# MINNESOTA DEPARTMENT OF NATURAL RESOURCES

## Record of Decision

**In the Matter of the Determination of the Need      FINDINGS OF FACT, CONCLUSIONS, AND ORDER  
for an Environmental Impact Statement for the  
3M Oakdale Surface Water Diversion Project, in  
Washington County, Minnesota**

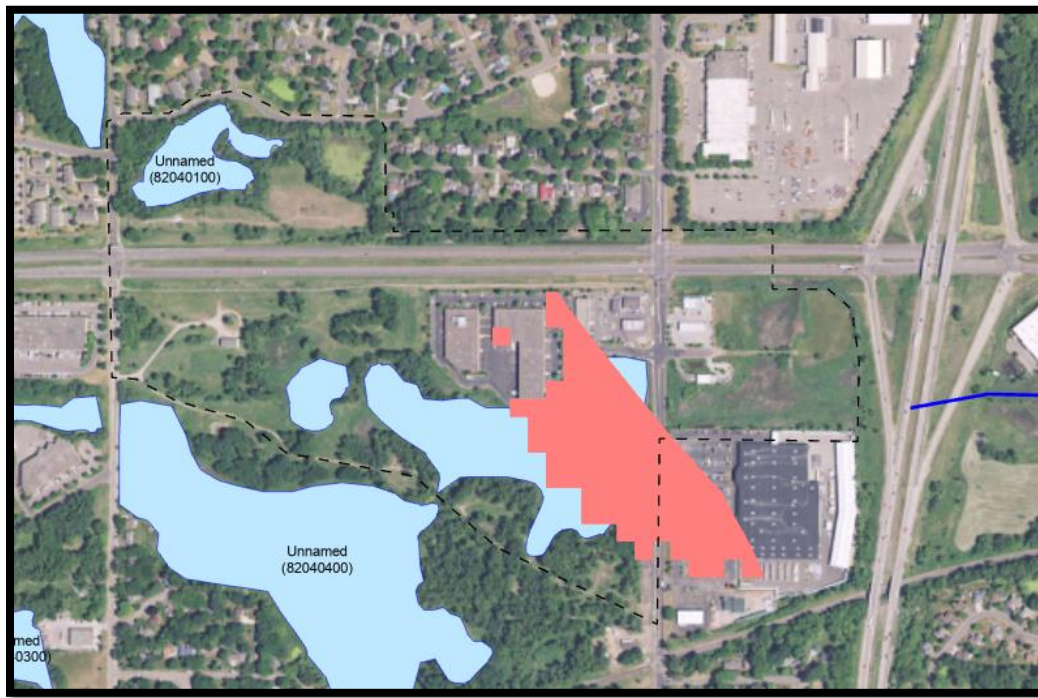
- c. The commenter notes that while this may not directly impact the project, it is important to note that the Minnesota DNR GIS layer “Regions Prone to Surface Karst Feature Development” has identified part of the Site, near Hadley Avenue, as prone to surface karst feature development (carbonate formation).

- e. Karst: Met Council notes that karst may exist in the community and that karst features have been mapped in communities to the north, east, and south, and references the GIS data layer 'Minnesota Regions Prone to Surface Karst Feature Development.

Two commenters noted that the DNR GIS data layer “Regions Prone to Surface Karst Feature Development” shows carbonate bedrock underlying the project area that crosses Hadley Avenue and overlaps with Wetland A and Pond A that may be prone to karst feature development (see image below, the project areas is shown by the black hashed lines, areas in blue are public water wetlands, the area in red/orange represents the carbonate layer).

The proposed stormwater diversion pipe and flood retention basin would be located outside of the delineated karst area; fencing would be installed within the mapped karst area. Approximately 92 fence posts would be installed within the wetland boundary, with the posts driven 72 inches below the ground surface.

Of 50 verified wells in the area (from the County Well Index), five encountered bedrock at depths below ground surface ranging from 42 to 81 feet. These wells indicate bedrock is deeper than the proposed construction activities in the project area. Project activities would not reach a depth greater than 72 inches for the fence. Excavation for the diversion pipe would be approximately 10 to 20 feet below ground surface for the majority of its length; therefore, the proposed project would not encounter bedrock and pose little risk with respect to karst.
